**Proposed Reliability Standard PRC-024-3
Frequency and Voltage Protection Settings for Generating Resources**

Project 2018-04 Modifications to PRC-024-2 Reliability Standard PRC-024-3

Figure 1

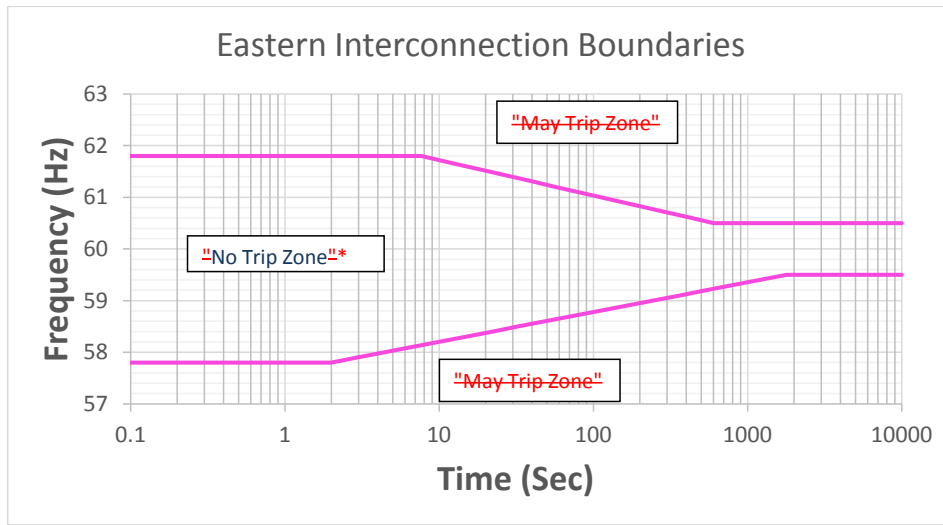
The revision to Figure 1 to label the area as a "May Trip Zone" is confusing. Exelon suggests explaining that if tripping, trip setpoint(s) need to be set to operate "on or below" the appropriate curve in lieu of labeling the region outside as a "May Trip Zone". This also will provide clarification for settings on the curve are considered compliant.

The revision to Figure 1 to label the area as a “May Trip Zone” is confusing. Suggest explaining that trips need to be set to operate “on or below” the appropriate curve in lieu of labeling the region outside as a “May Trip Zone”. This also will provide clarification for settings on the curve are considered compliant.
